Model	VT2100/2130/2150, Ges5310/5315/5320, Rex1240/1241/1242, NSA CP310/315	Volt/Hz	Date of Modification	Serial Number
Modified Article	Parts Catalog			
Reason for Modification	Parts catalog correction

1. Description correction

Page 54 PLOTTER / MASTER FEED SECTION II

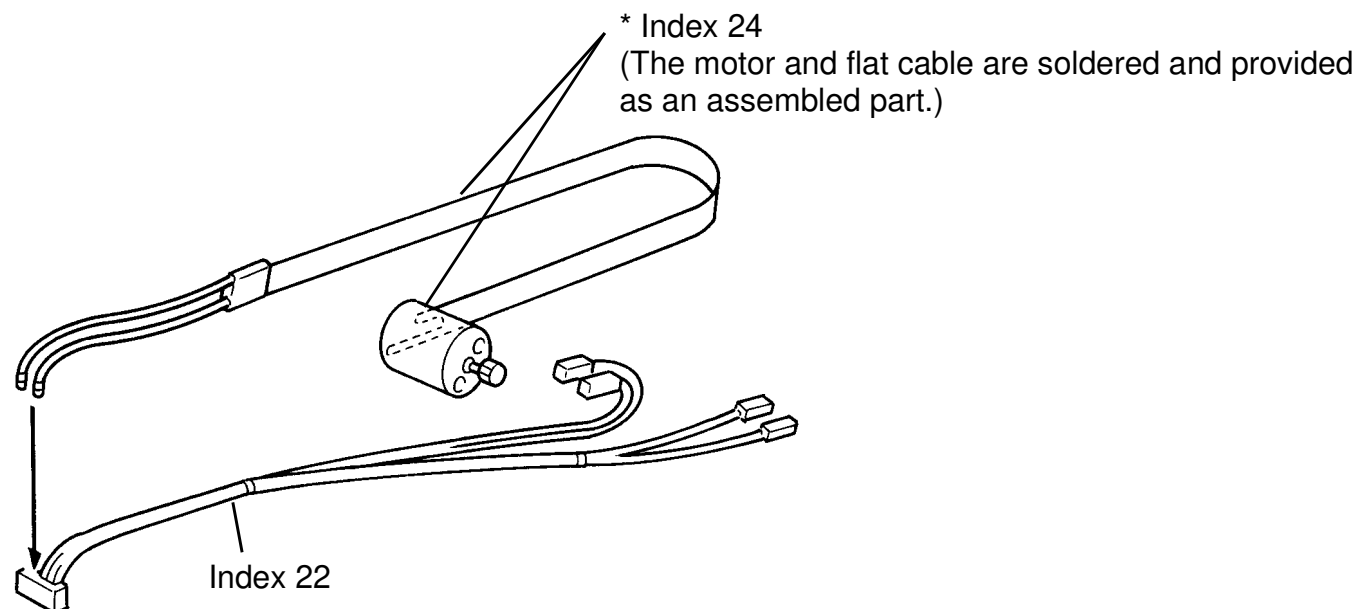
Correct the illustration for the cutter motor (C2008415) as follows:

Page 57 PLOTTER / MASTER FEED SECTION III**All versions**

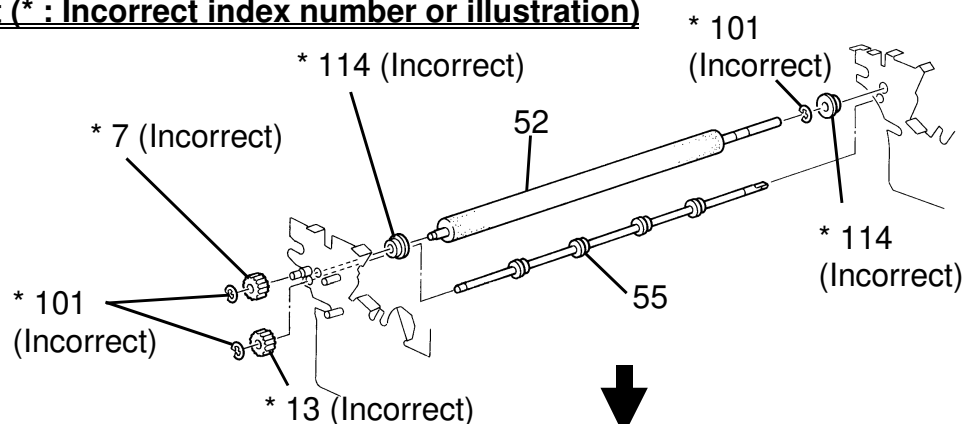
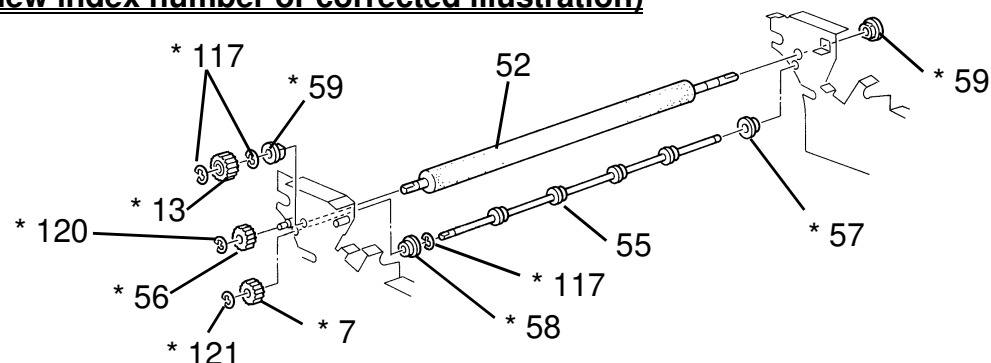
Add the following parts and correct the illustration as shown below:

New Index	P/N	Description	Q'ty
56	C2002338	Gear - 20T	1
57	53241658	Bushing - 4 x 8 x 4.5 mm	1
58	H0022226	Bushing - Head Roller	1
59	H0121181	Bushing - M6	2
120	07200020Z	Retaining Ring - M2	1
121	07200025Z	Retaining Ring - M2.5	1
